*Revised Structure Type Study*

**Ramp B over Norfolk Southern Tracks  
SCI-823-1598**

**SCI-823-10.13  
PID No. 79977**

- ODOT Review Comments of Original Structure Type Study with Consultant Responses

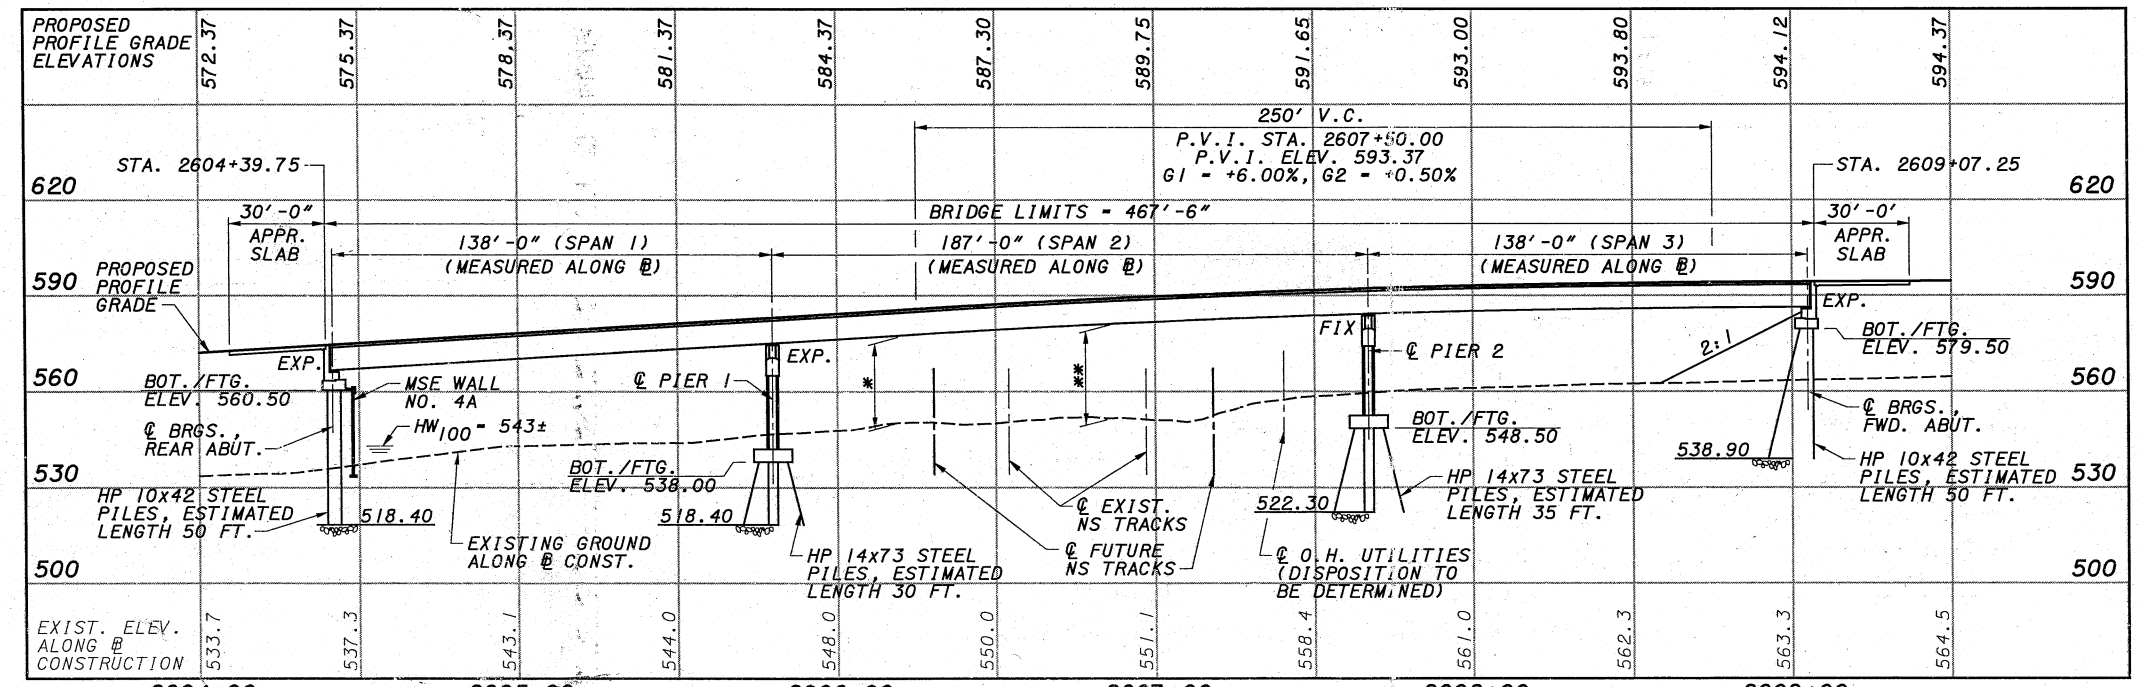
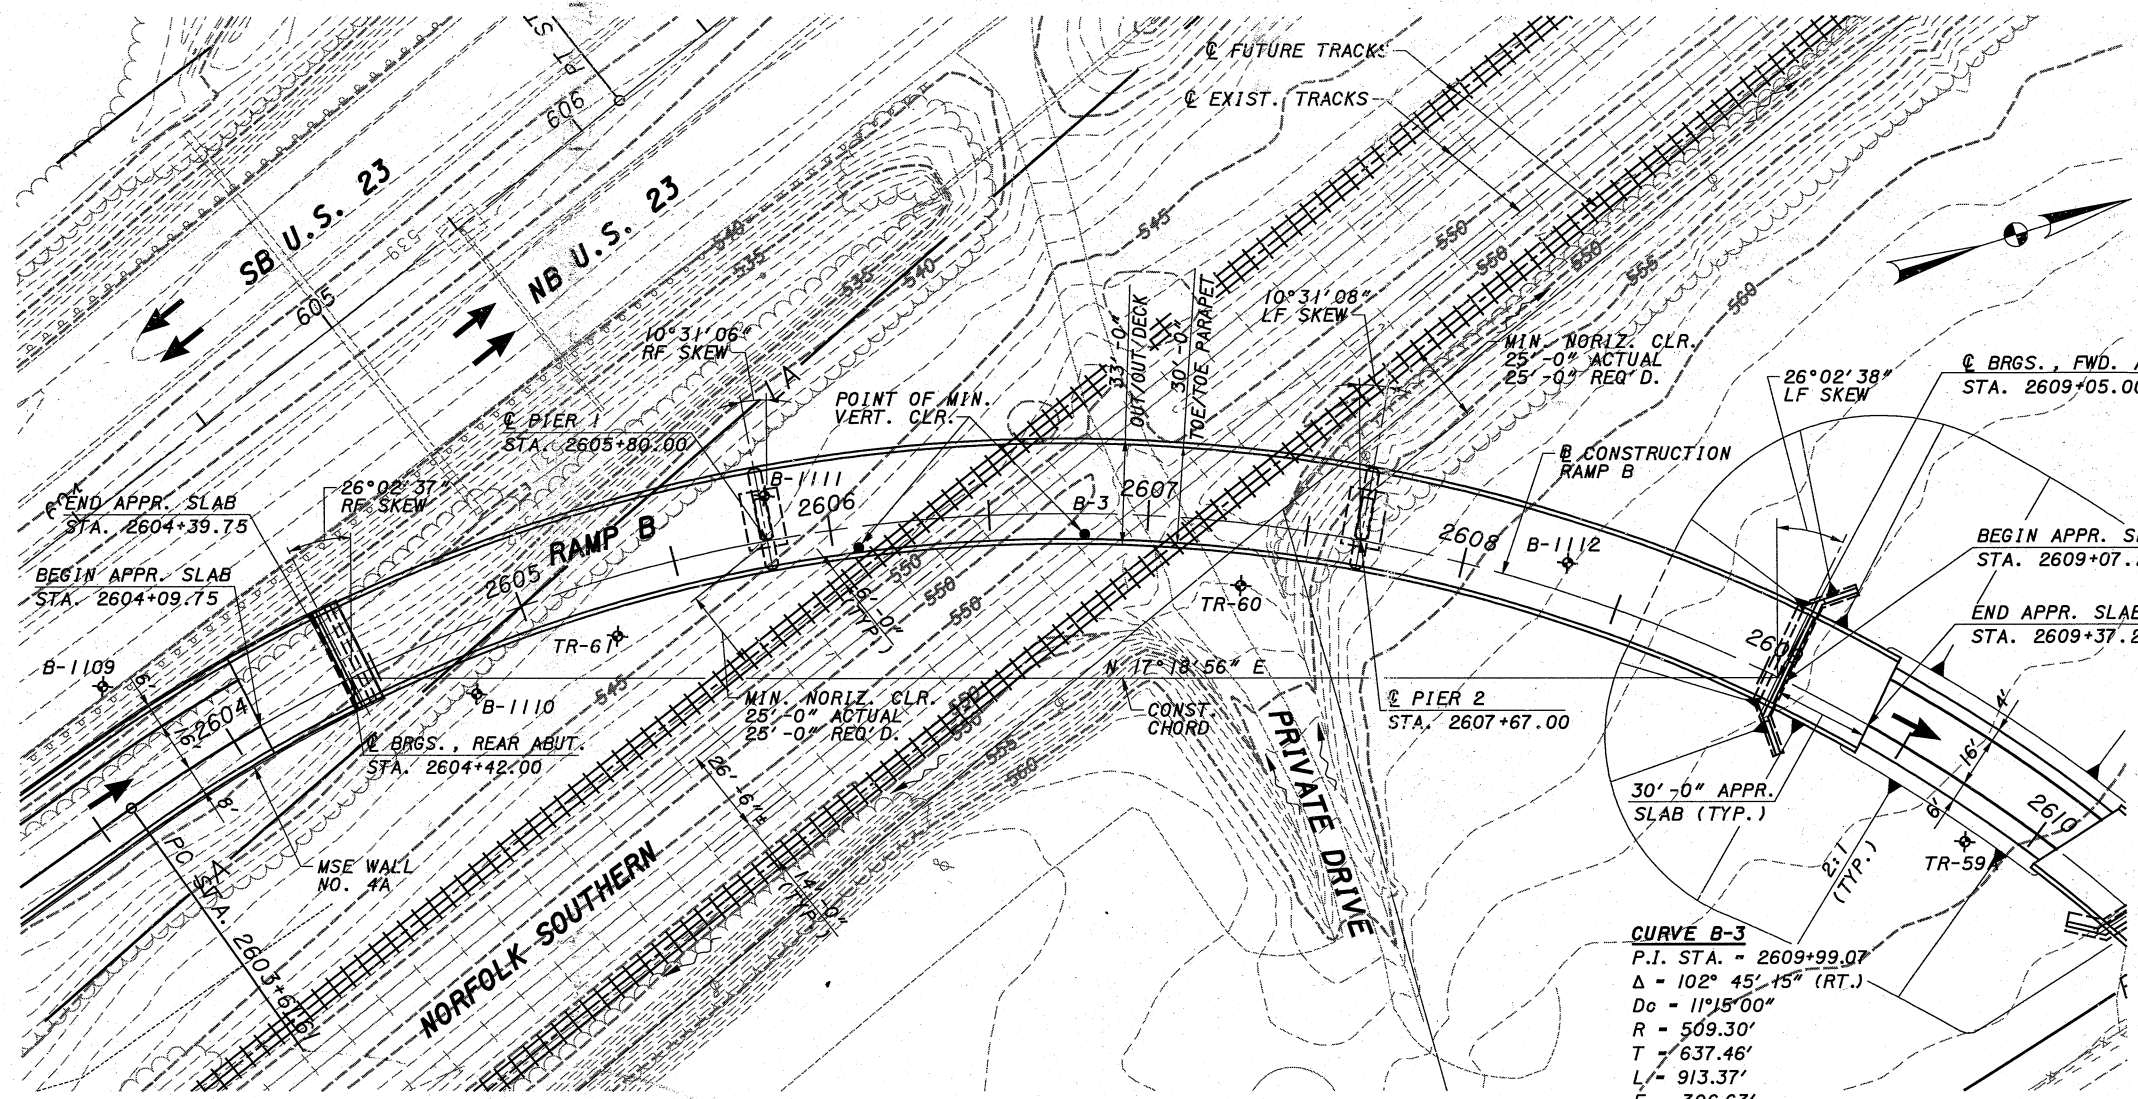
Site Plan (1/3)	9. The callout <b>RAMP B</b> is also being used at the South end of the project. In order to avoid confusion, please consider using a different callout for this ramp.	CH2M HILL will coordinate with TranSystems.

Site Plan (1/3)	10. In the Profile view, a stream is being shown to the north of the proposed pier in Alternate 1. Please show the edge limit of the stream in the Plan view and the direction of the flow. How much flow is in the stream? Please provide additional information.	CH2M HILL intends to maintain the existing drainage, grading, and location of the ditch in this area for this project. The existing ditch is located in close proximity to the potential future track. As such none of the newly proposed span arrangements result in substructures conflicting with this existing ditch. Existing and proposed flow arrows for this ditch will be provided in the plans.
Site Plan (1/3)	11. Show the vertical clearances for both railroad tracks. Profile view only showed the vertical clearance for one of the railroad tracks.	Will comply.
Site Plan (1/3)	12. Verify all vertical clearances. Norfolk Southern Railroad requires that the 23'-0" minimum vertical clearance is measured from top of high rail to the lowest point of the structure in the <u>horizontal clearance area</u> .	Will comply.

Site Plan (1/3)	13. Please investigate the use of straight or 45 degree turnback wingwalls instead of turnback wingwalls.	Will comply. 45 degree turnback wingwalls will be used where applicable.
Site Plan (1/3)	14. Please justify the limit of the MSE walls on both sides of Ramp B. Along Ramp B, a 2:1 slope shall be utilized whenever possible to minimize the length of the walls.	Will comply. MSE walls will be terminated as quickly as possible.

Site Plan (1/3)	15. Provide Project Identification Number (PID) below the County-Route-Section in the Title Block as per Section 102.5 of the 2004 Ohio Bridge Design Manual (BDM).	Will comply. CH2M HILL has been notified that PID number for this project is 79977.
Site Plan (1/3)	16. Include the Structure File Number in the Title block. Structure File Number can be obtained by contacting Ms. Kathy J. Keller, Office of Structural Engineering, Bridge Inventory section (Phone: 614-752-9973) <u>prior to Stage 1 (Preliminary Design) submission.</u>	Will comply. CH2M HILL has been notified that the Structure File Number for this bridge is 7306717.
